Project	IEEE 802.16 Broadband Wireless Access Working Group < http://ieee802.org/16 >	
Title	Enhanced H-ARQ MAC Support for MIMO OFDMA	
Date Submitted	2004-06-25	
Source(s)	Geunhwi Lim, Wonil Roh, JeongTae Oh, Chan-Byoung Chae, Kyunbyoung Ko, Hongsil Jeong, Sung-Ryul Yun, Seungjoo Maeng, Panyuh Joo, Jaeho Jeon, Yong Chang, TaeWon Kim	wonil.roh@samsung.com Voice: +82-31-279-3868
	Samsung Electronics Co., Ltd. 416, Maetan-3, Yeongtong, Suwon, Gyeonggi, Korea 442-600	
Re:	Contribution supporting TGe WG ballot #14b	
Abstract	Enhanced H-ARQ MAC Support for MIMO OFDMA	
Purpose	Adoption of proposed changes into P802.16e	
Notice	This document has been prepared to assist IEEE 802.16. It is offered as a basis for discussion and is not binding on the contributing individual(s) or organization(s). The material in this document is subject to change in form and content after further study. The contributor(s) reserve(s) the right to add, amend or withdraw material contained herein.

Enhanced H-ARQ MAC Support for MIMO OFDMA

Figure 1 shows the region allocation when using H-ARQ MAP messages in the frame.

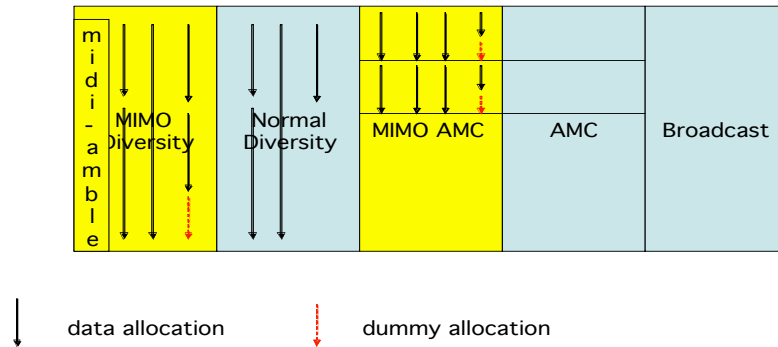
[add a new section 6.3.2.3.43.6.10]

The MIMO midamble is placed at the very first symbol in the region defined by H-ARQ Format Configuration IE.

Syntax	Size	Notes
MIMO Region Compact_DL-MAP_IE () {	-	-
DL-MAP Type	3 bits	Type = 7
DL-MAP Sub-Type	5 bits	MIMO Region = 0x03
Length	4 bits	Length of the IE in Bytes
Number Symbols for MIMO Diversity Region	4 bits	MIMO diversity region is placed before the normal diversity region
Number Symbols for MIMO AMC Region	4 bits	MIMO AMC region is placed before the normal AMC region
}	-	-
